ORIGINATION FORM

Proposed Revisions to a Standard Plans Index (Please provide all information – Incomplete forms will be returned)

Index Number: **700-120** Sheet Number (s): 1-9 Index Title: Electronic Display Sign - Roadside Flashing Beacons

CHANGED INDEX TITLE TO: ENHANCED HIGHWAY SIGNING ASSEMBLIES

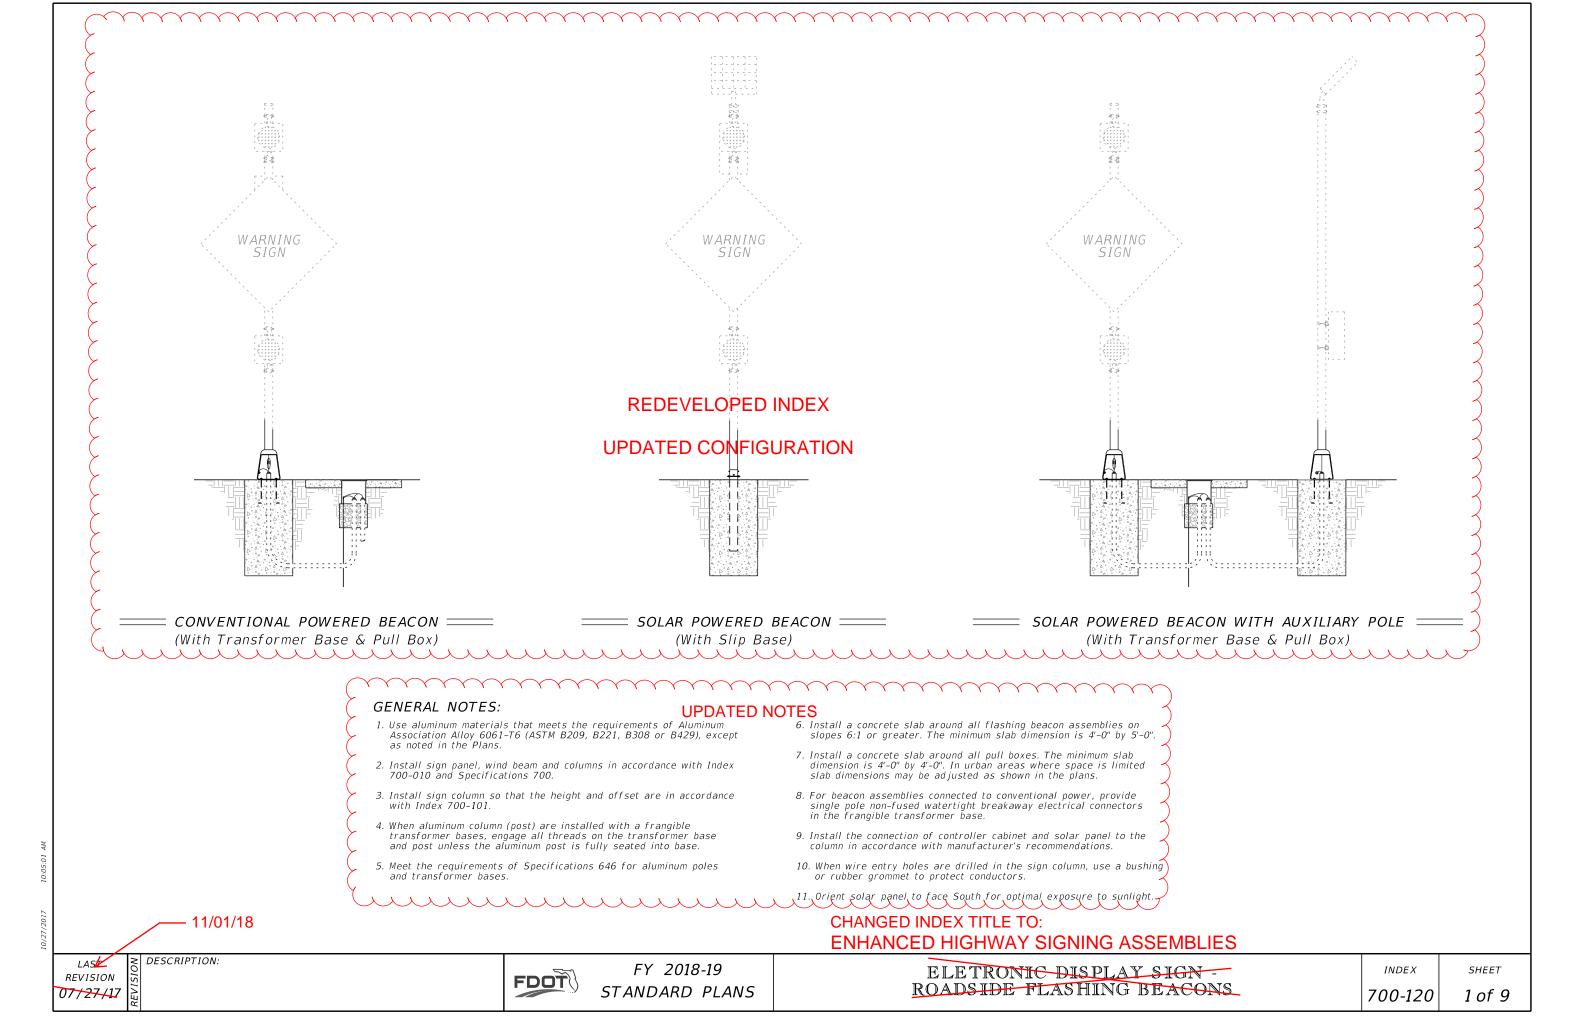
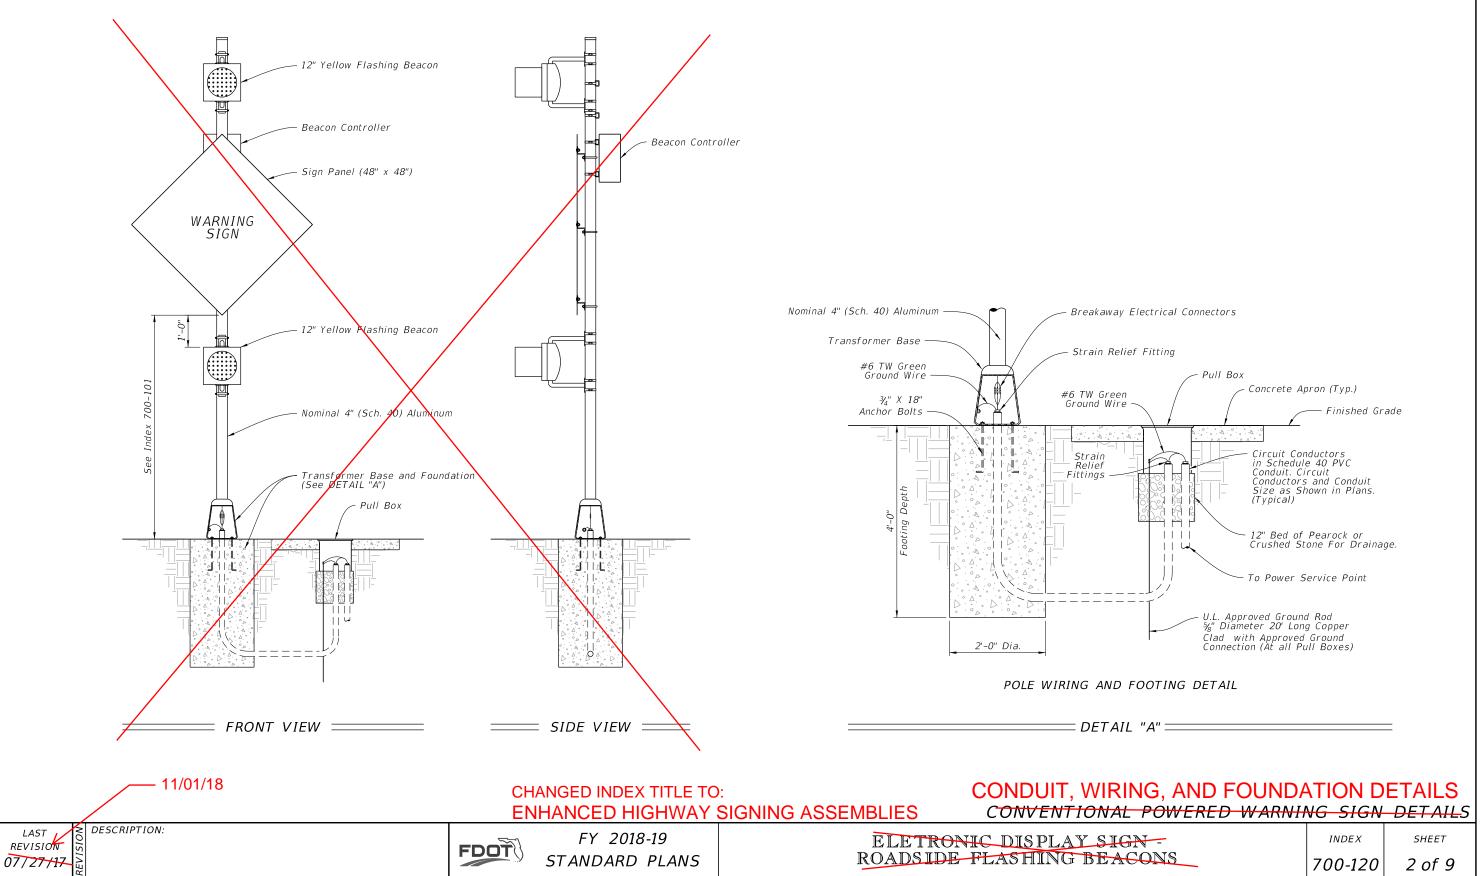
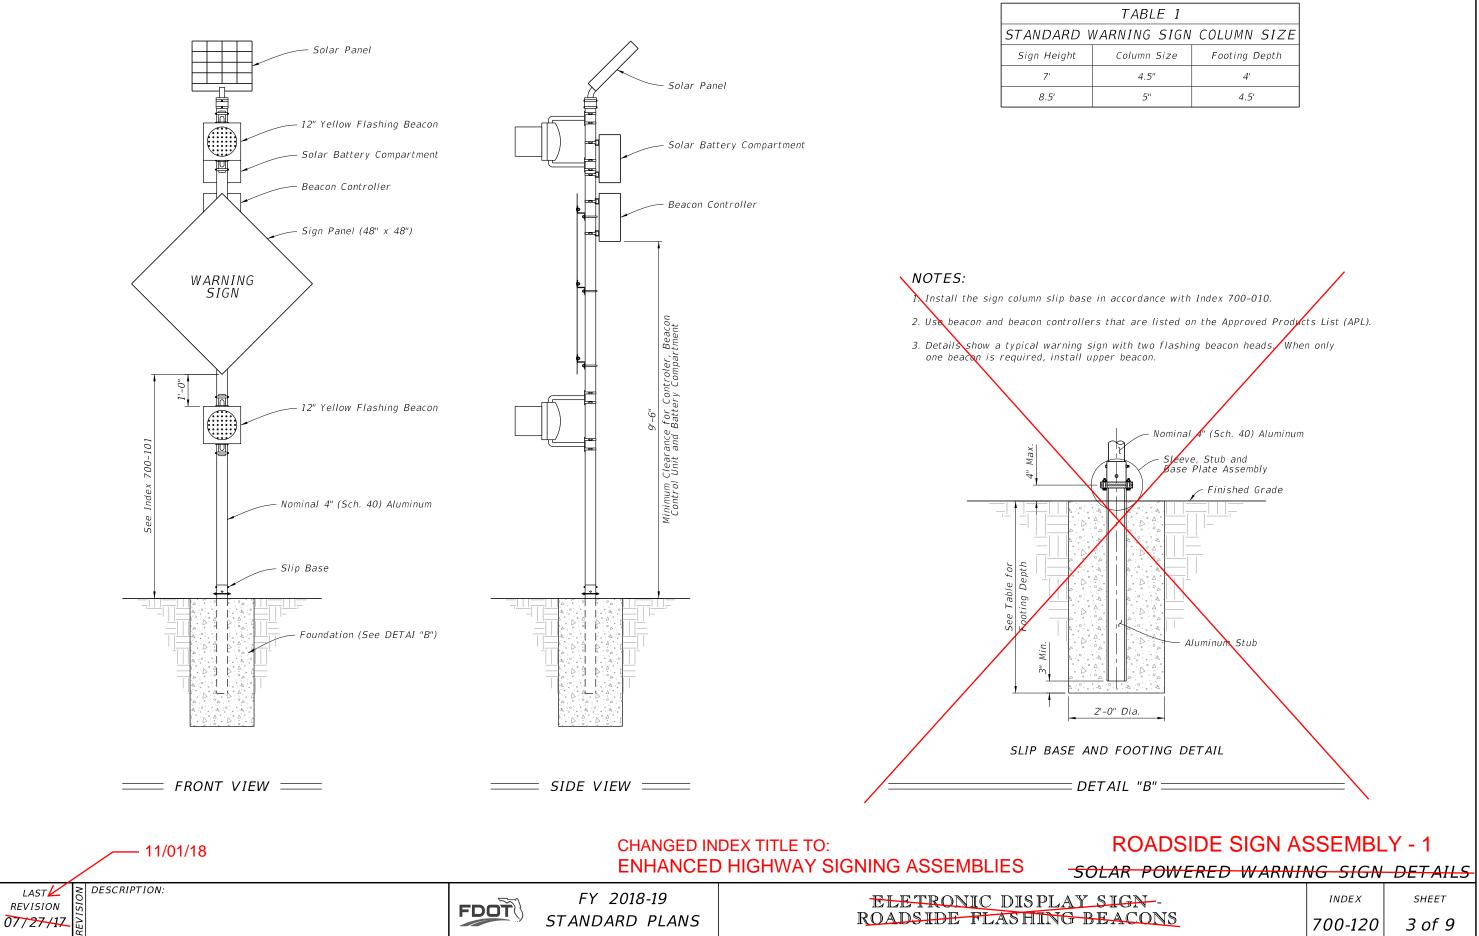
Redeveloped Index; Renamed Index, Added Configurations and Assembly type designations to combine for a new Alpha-Numeric Identification process.

The primary concern was that some signs (the RRFB in particular) were mounted too low and may interfere with sidewalk users. Also, it was not readily apparent that Conventional-Power and Solar-Power was an option for each assembly type.

ROADSIDE SIGN ASSEMBLY - 3

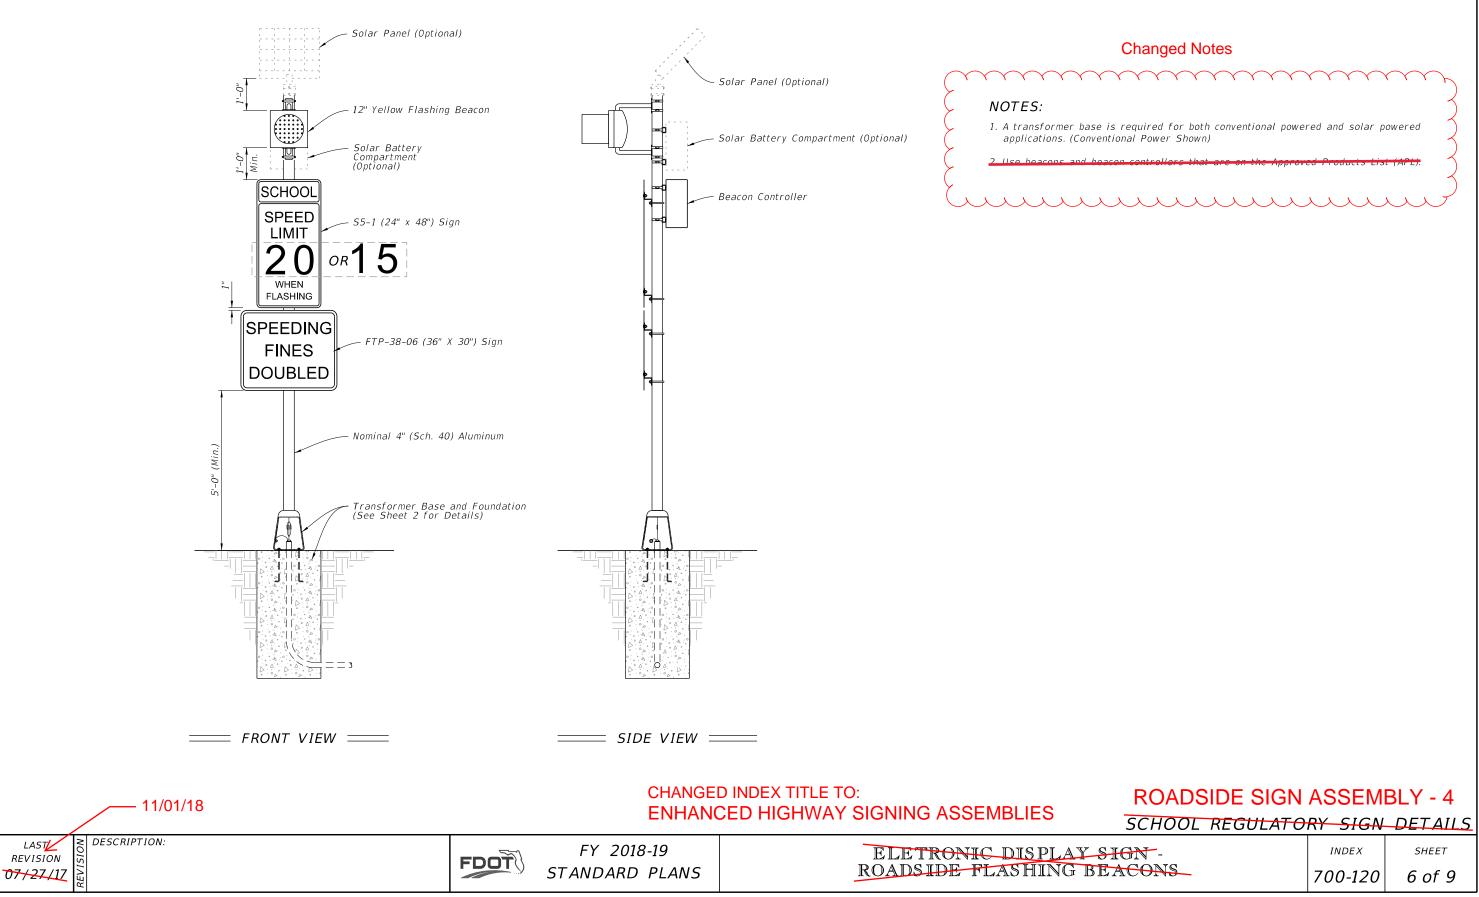
anged	Notes

ROADSIDE	SIGN AS	SEMBLY-3
	INDEX	SHEET
SEMBLIES	700-120	5 of 9

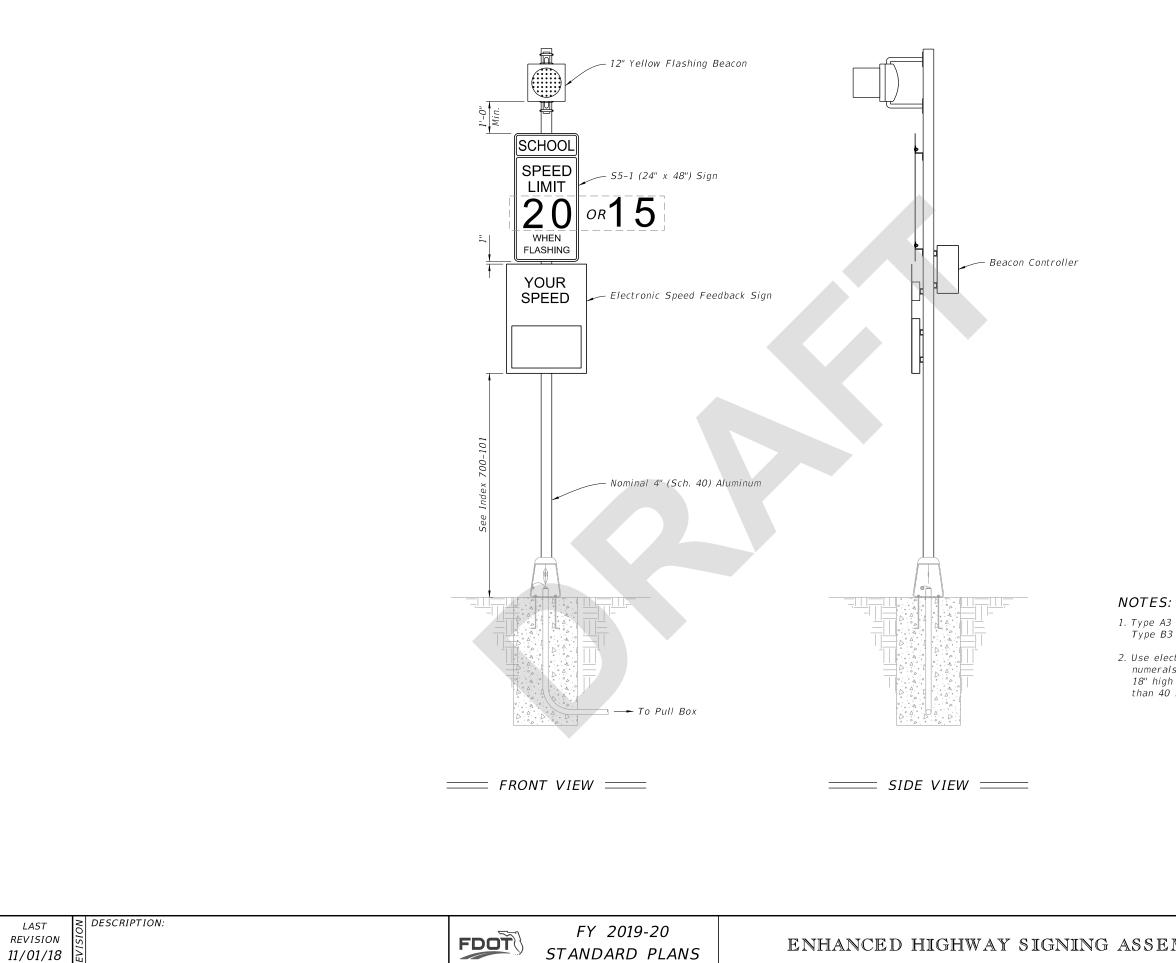
2. Use electronic speed feedback sign with 15" high numerals for posted speed of 45 mph or less, and 18" high numerals for posted speeds greater than 40 mph.

ROADSIDE	SIGN AS	SEMBLY-5
	INDEX	SHEET
SEMBLIES	700-120	7 of 9

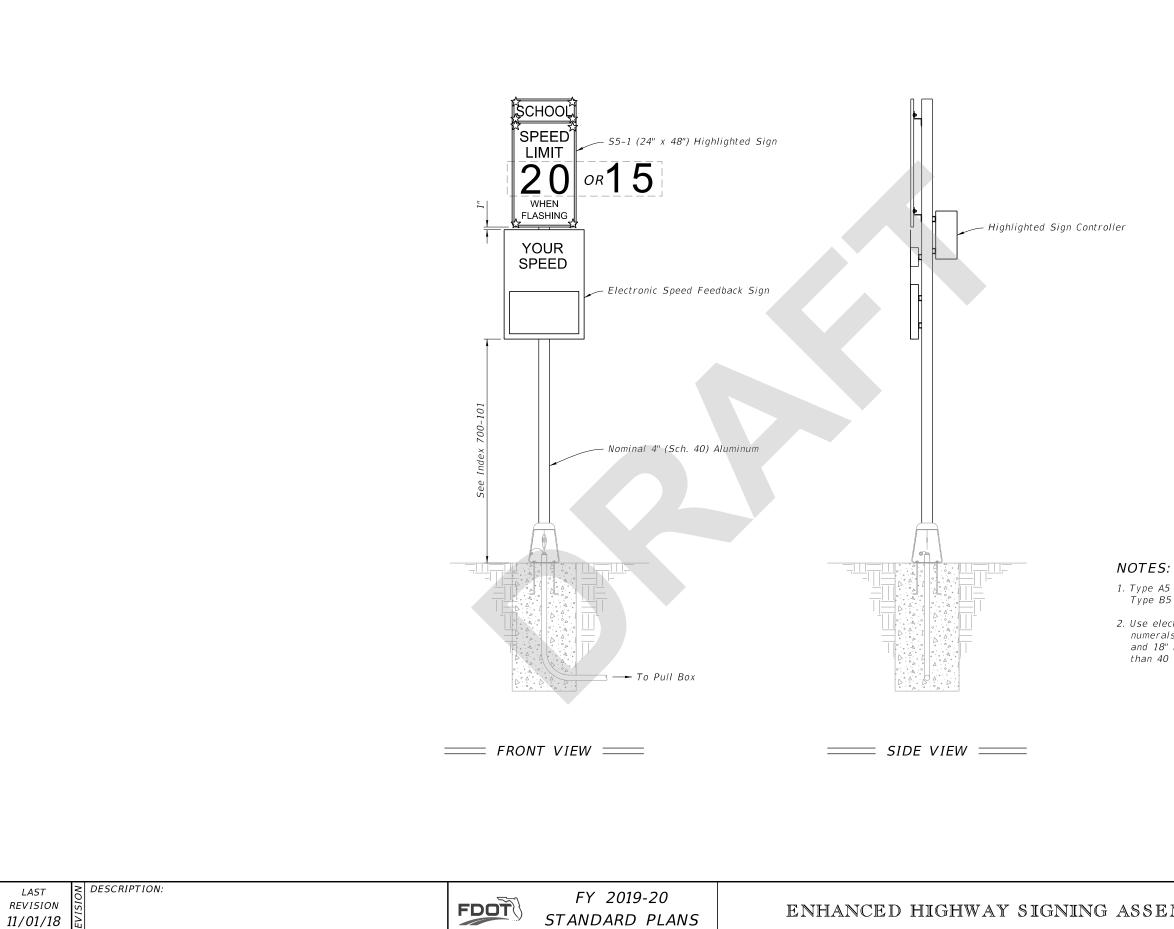
2. Use electronic speed feedback sign with 15" high numerals for posted speed of 45 mph or less, and 18" high numerals for posted speeds greater than 40 mph.

ROADSIDE .	SIGN AS	SEMBLY-6
SEMBLIES	INDEX	SHEET
	700-120	8 of 9

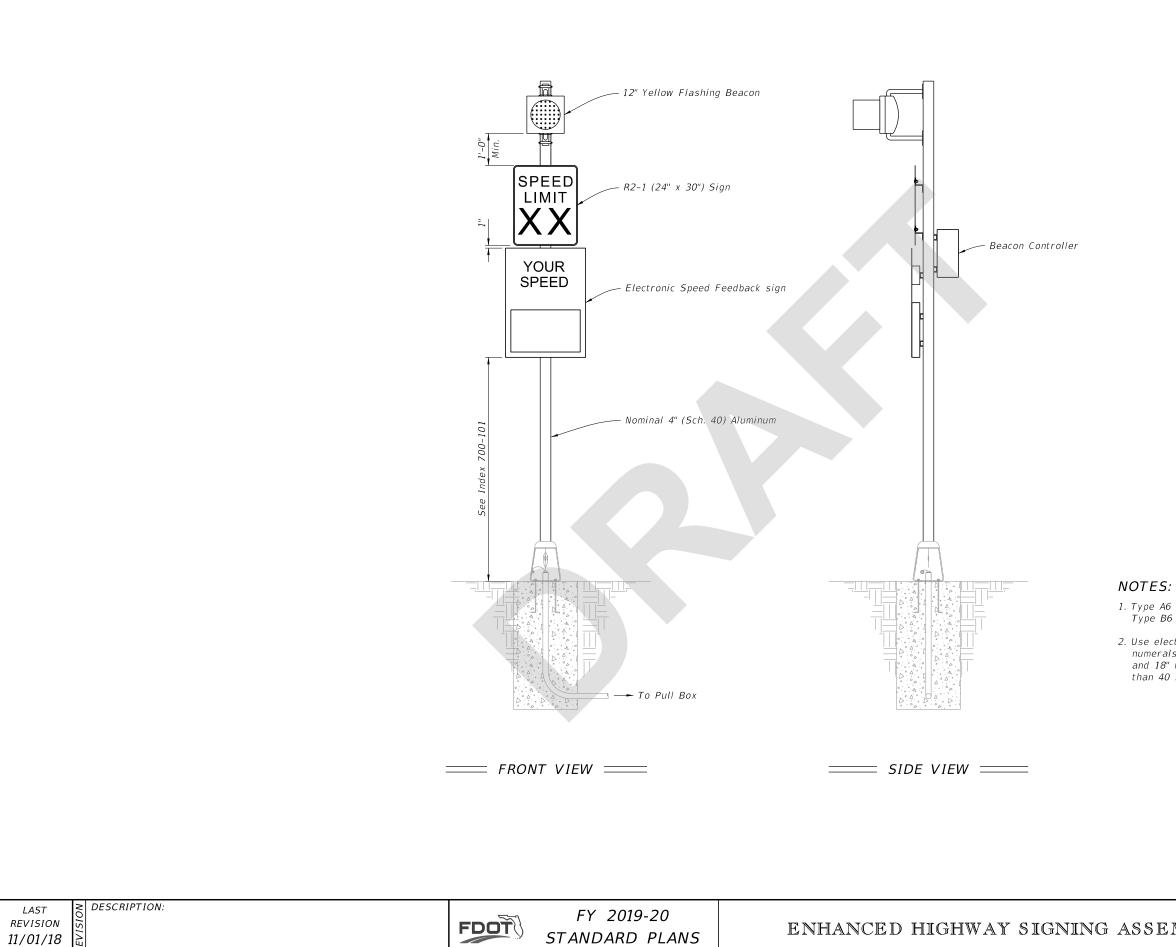
2. Use electronic speed feedback sign with 15" high numerals for posted speed of 45 mph or less, and 18" high numerals for posted speeds greater than 40 mph.
